### THM 4L60-E NEW "DEEP" BOTTOM PAN AND FILTER FOR 1998

**CHANGE:** Beginning at the start of production for 1998 model vehicles, there was a new design bottom pan

Figure 1
AUTOMATIC TRANSMISSION SERVICE GROUP

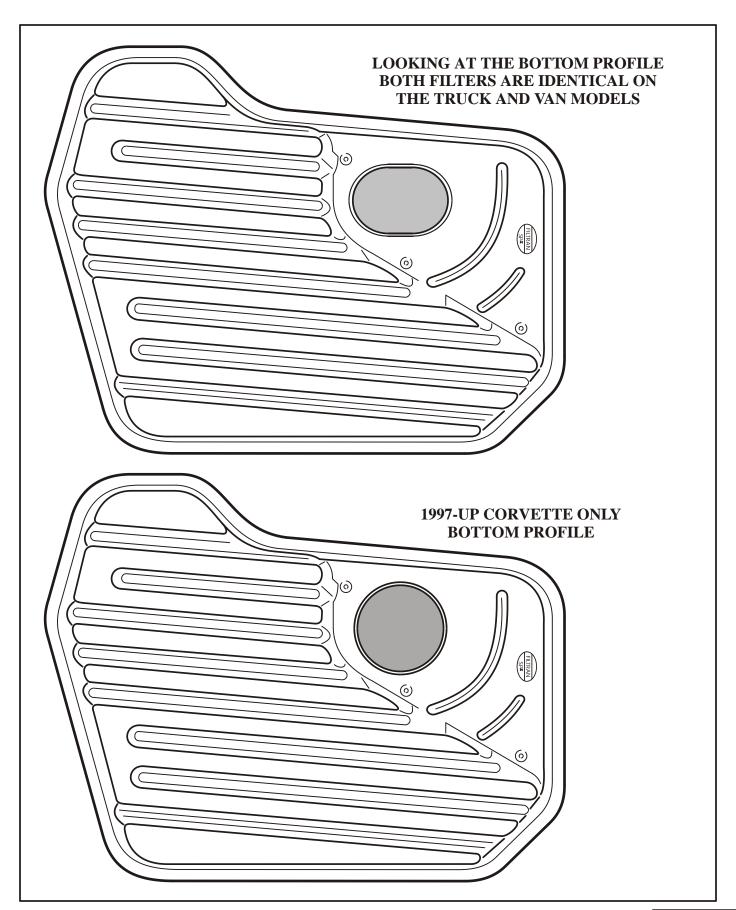
Bottom pan filters must be used with the correct design level bottom pans and must be used on the models that they were intended for, as shown in Figures 1, 2, and 3.

Figure 2
AUTOMATIC TRANSMISSION SERVICE GROUP

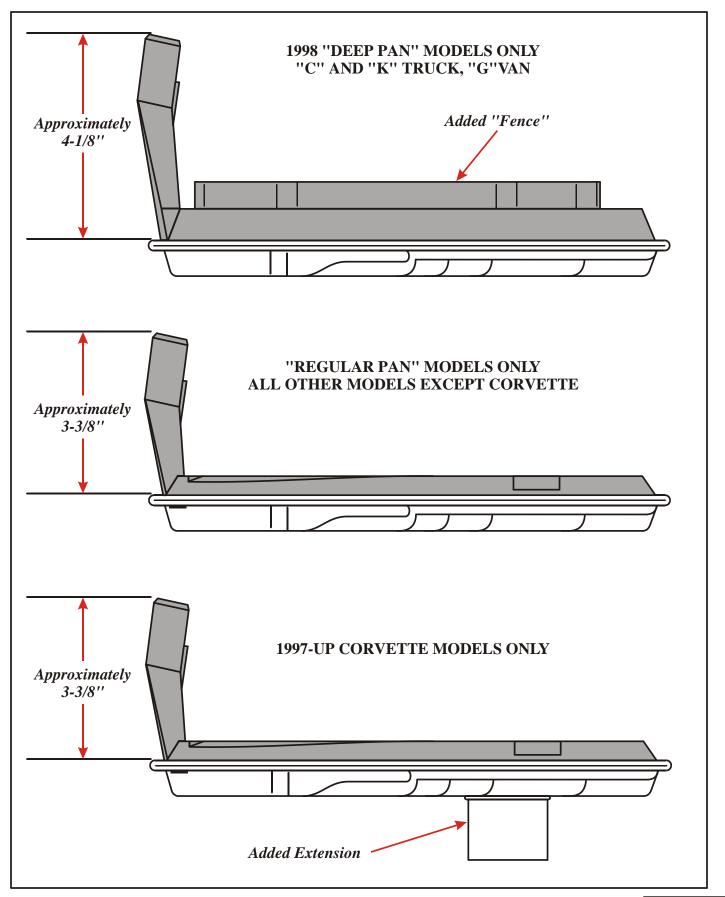
- (1) BOTTOM PAN New design is approximately 17mm deeper than the regular pan, and all three bottom pans used in 1998 models are illustrated in Figure 3 for identification purposes.
- (2) BOTTOM PAN FILTER There are now three different filters for the 1998 model year. The bottom profile of the filters are all the same as shown in Figure 1. The side profiles however are different as the "Deep" pan requires the filter with the longer neck, the "Regular" pan requires the filter with the shorter neck, and the 97-up Corvette requires the filter with the added extension on the bottom. Refer to Figure 2.
